Value Engineering Study

I-65 WIDENING

**ITEM NUMBER 4-15.00, 4-16.00, 4-17.00, 4-18.00, 4-19.00
VE STUDY NUMBER 201302**

Final Report

VALUE ENGINEERING RECOMMENDATION # VE-9
PHOTOGRAPH OF EXAMPLE SIMILAR TO ORIGINAL DESIGN

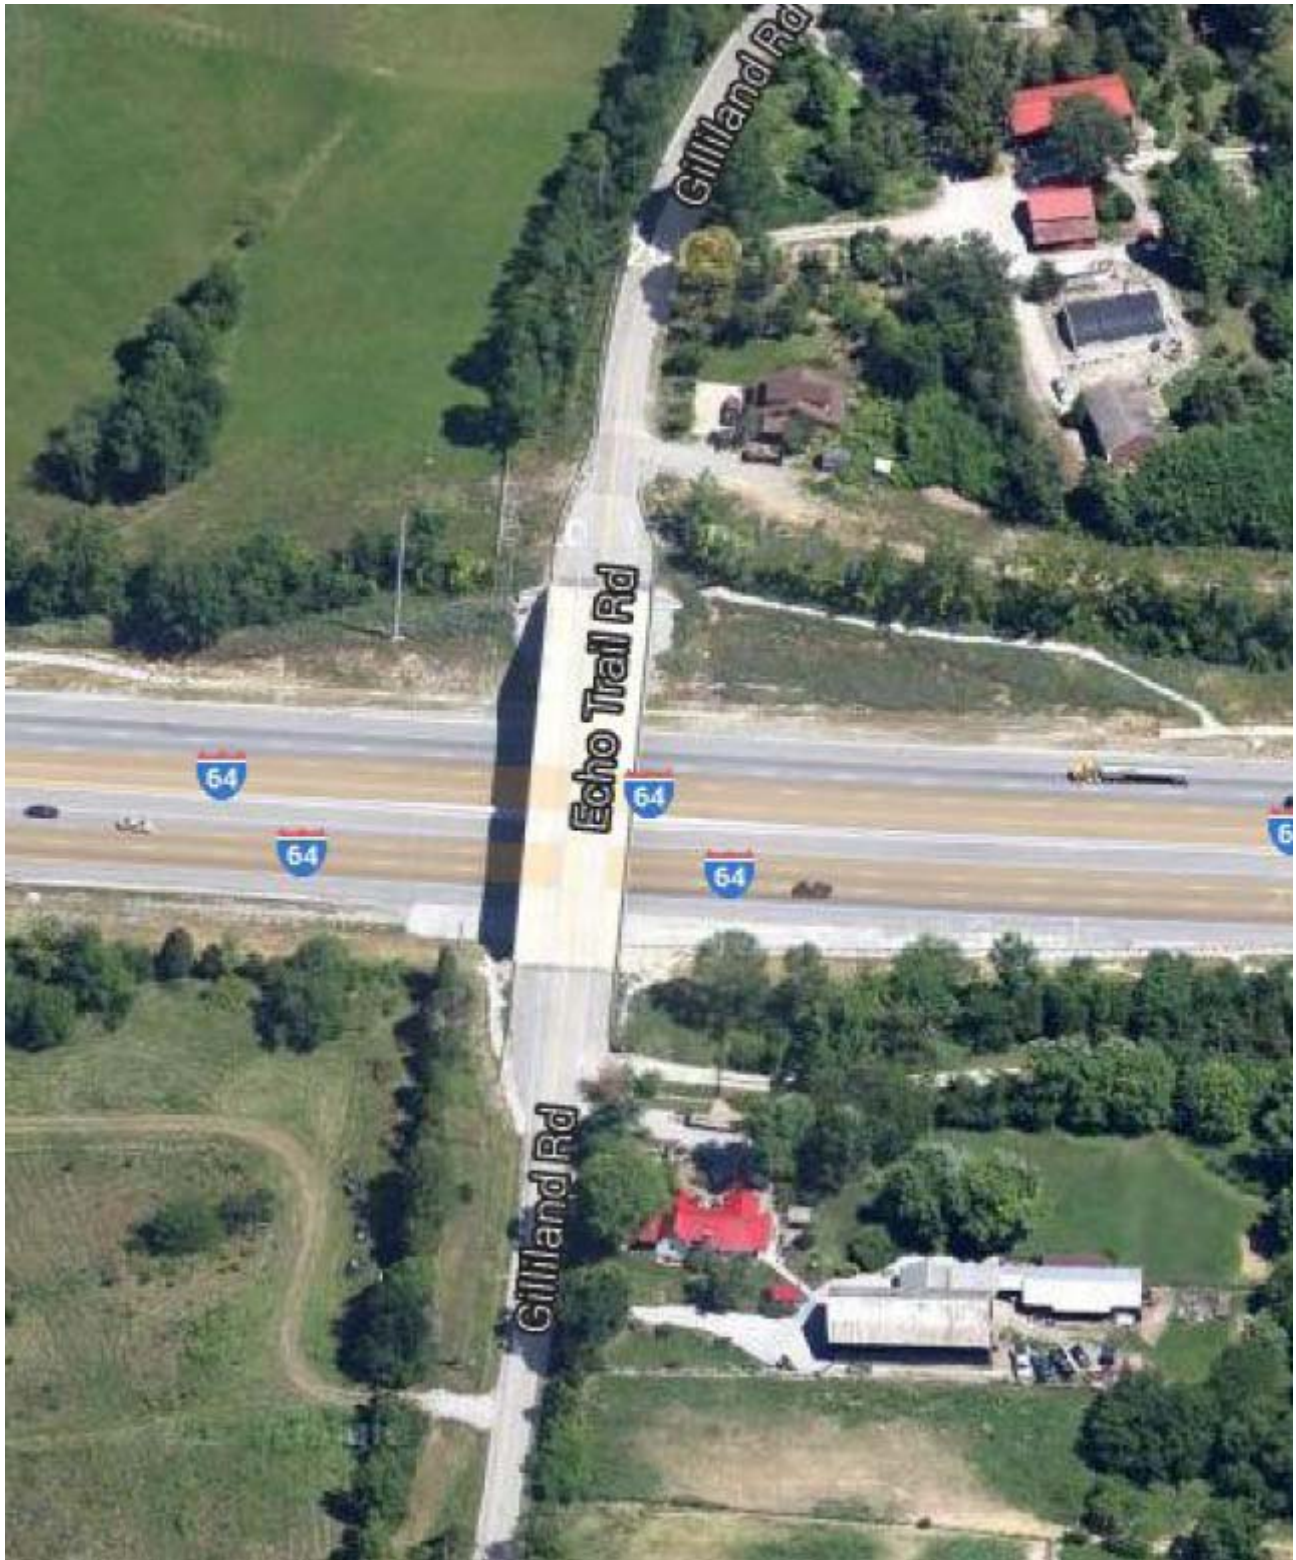
At Old Sonora Road, KY 1407, and KY 1136, replace overpass bridges with bridges similar to existing width (~24 ft) in lieu of 32 ft wide bridges.

The VE Team recommends that the proposed bridges each have a deck width based on two 9 ft lanes with 4 ft shoulders (29 ft fascia-fascia) with similar pavement modifications.

The current land use and roadways do not show evidence of impending improvements nor a need for widening in the near future. In the absence of a significant traffic increase, then the bridges do not need to be wider than the approach roadways. A 26 ft width should allow passing of a stalled vehicle or allow the occasional use of extra wide farm equipment if given adequate stopping sight distance.

VALUE ENGINEERING RECOMMENDATION # VE-10

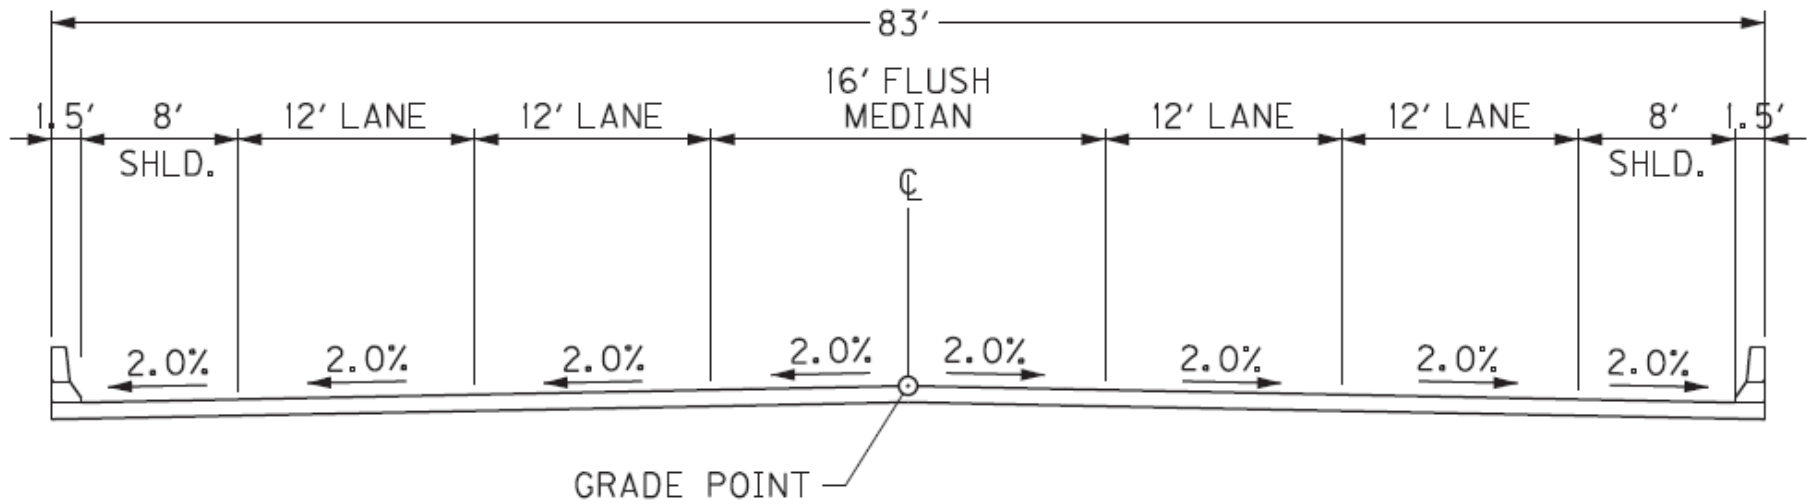
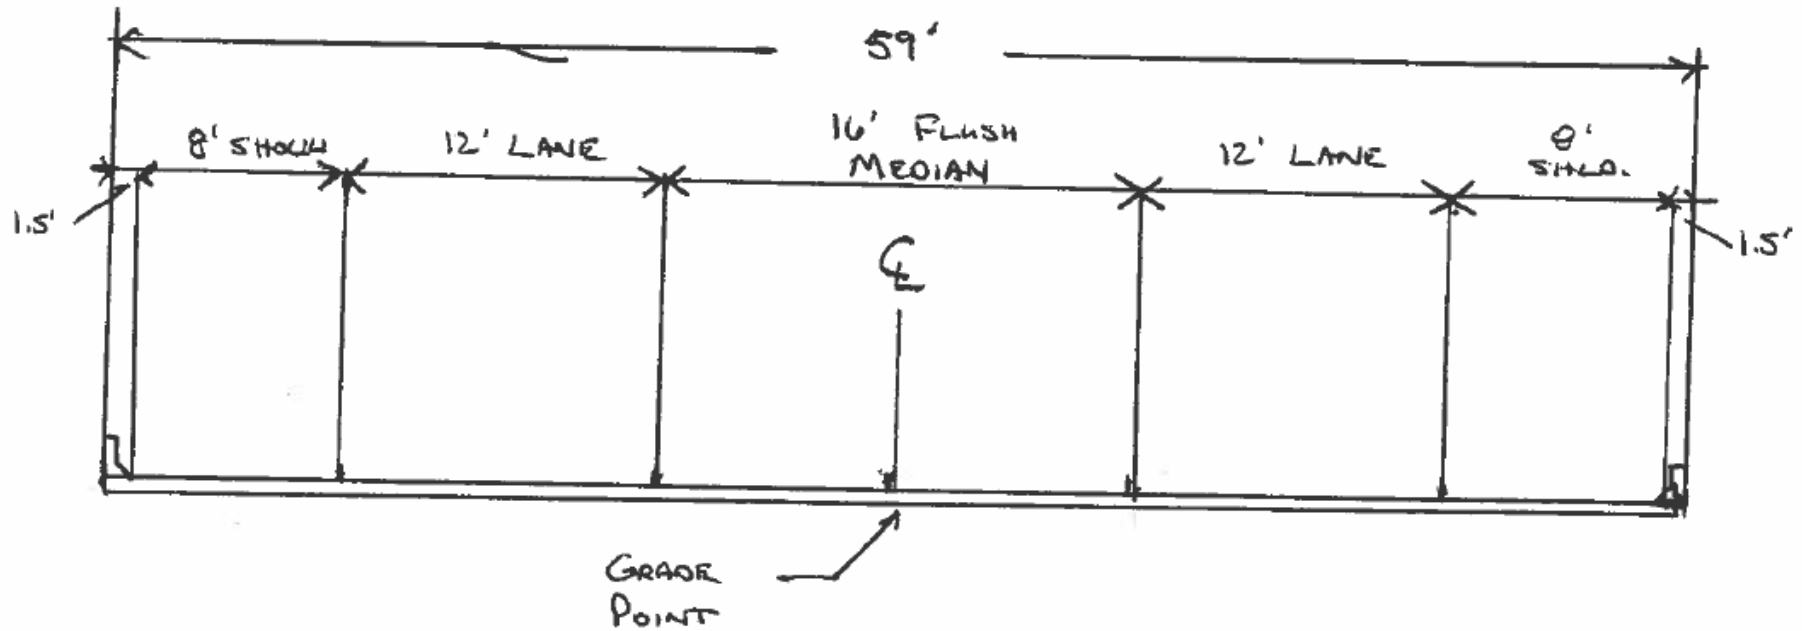
The original design specifies a 5-lane typical section with on KY 84 across I-65 based on forecasted traffic. Included in the forecasted traffic was based on a potential auto plant to the north of this interchange. The forecast determined that a 5-lane typical section (2 lanes per direction and a left-hand turn lane) was warranted in the 2025 design year.

The VE Team’s recommendation is based on new traffic volume data. The original forecast was based on 1999 existing traffic volumes and forecasted at a growth rate that is no longer applicable. Discussion with the Division of Planning provided guidance on obtaining a more realistic anticipated volume in the design year. The average growth rate on KY 84 has ranged from 0.1% on the west side to 0.4% on the east side of I-65. Using the updated forecast and guidance from the Division of Planning an acceptable LOS can be obtained while reducing the structure width and the approaches.

VALUE ENGINEERING RECOMMENDATION # VE-13

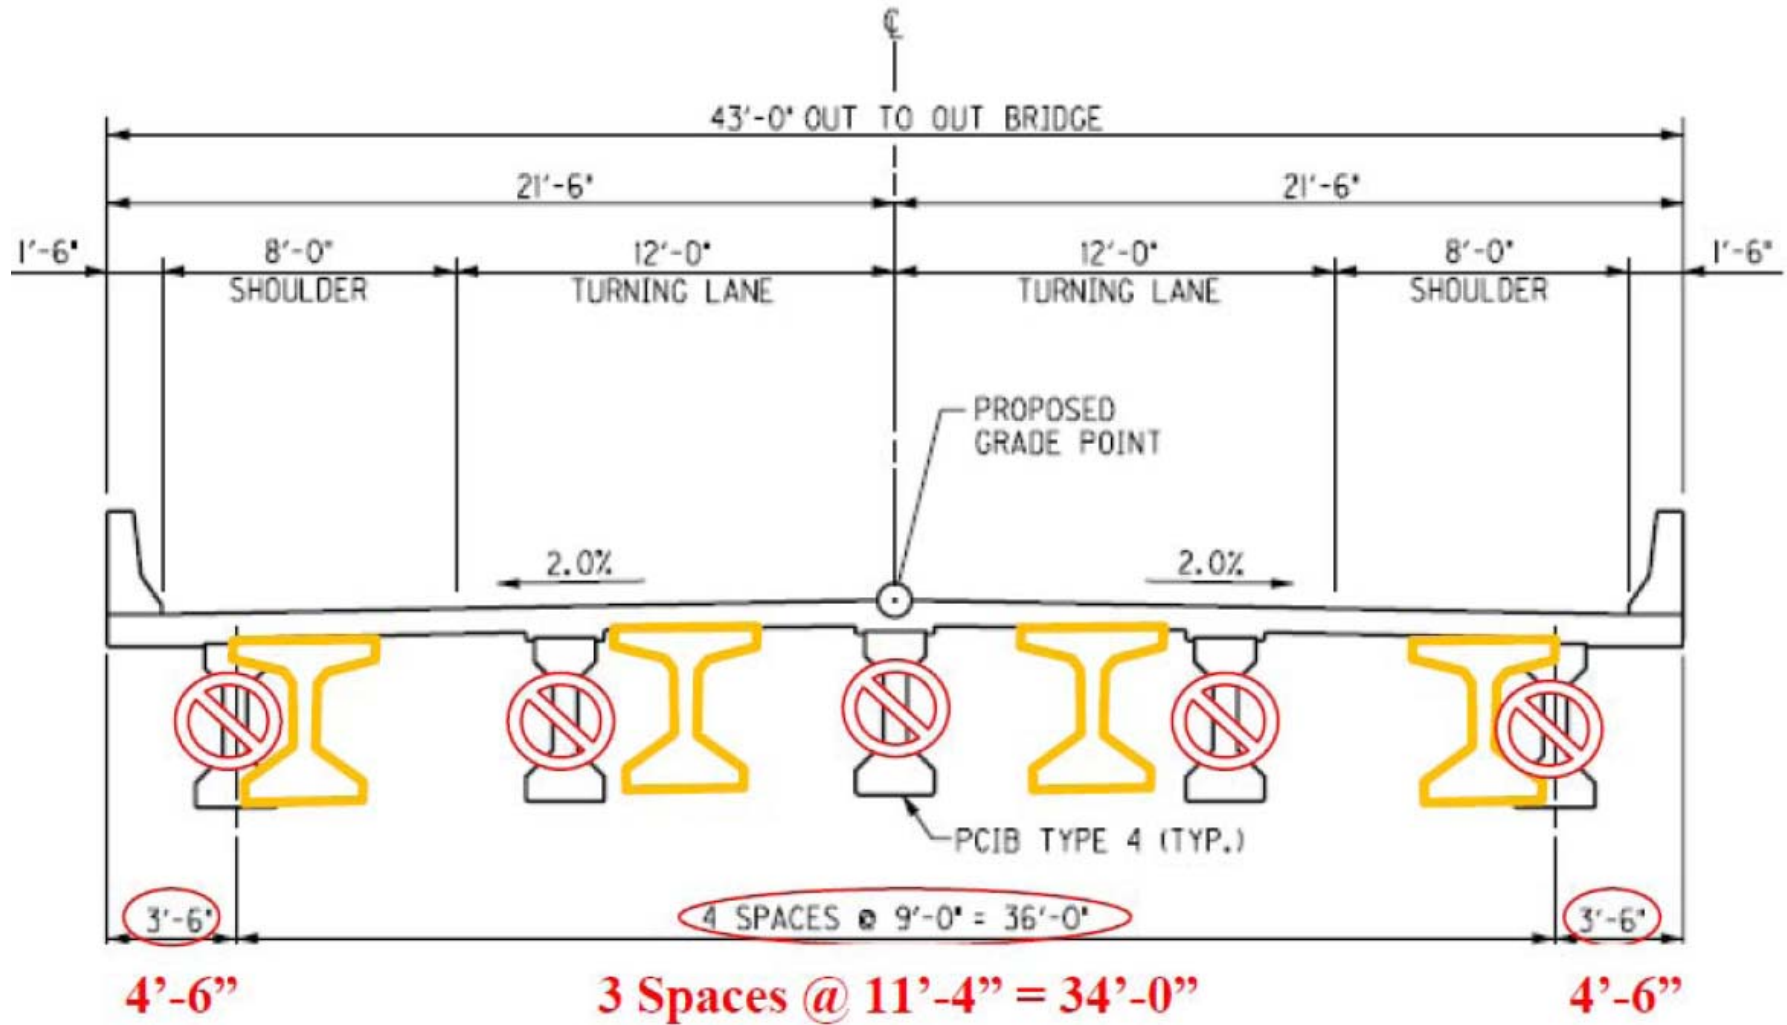
- Requires additional steel reinforcement in the deck or deck thickness
- May require a change in beam shape and/or additional capacity of the beam

The cost of precast concrete beams is a substantial cost in the construction of bridges. The savings realized from eliminating a beam line is usually not offset by the increased costs of accommodating the increased beam spacing (see disadvantages above for a list of these potential impacts). The recommended typical section of the Nolin River and Rhudes Creek Bridge matches the original design shown in the preliminary plans of the I-65 bridge over Bacon Creek. These three mainline bridges are the same width (129 ft-6 in.) and have the same maintenance of traffic scheme.

VALUE ENGINEERING DESIGN COMMENT # VE-17

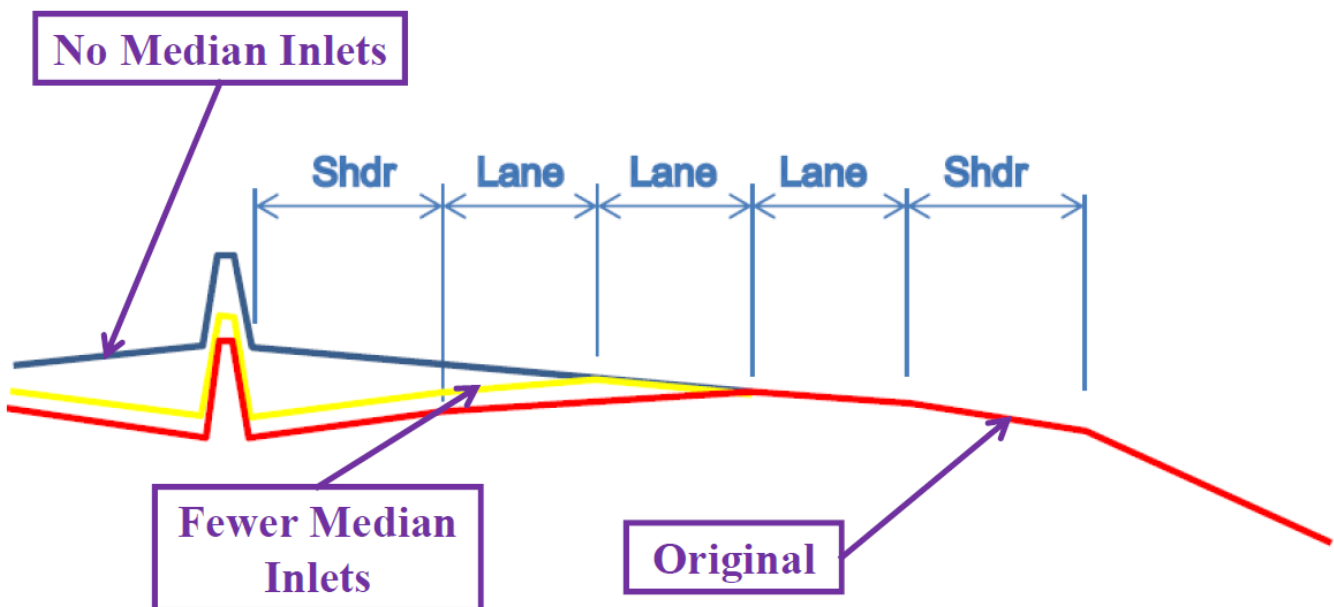
Replace ROW fence only as needed in lieu of full fence removal and replacement.
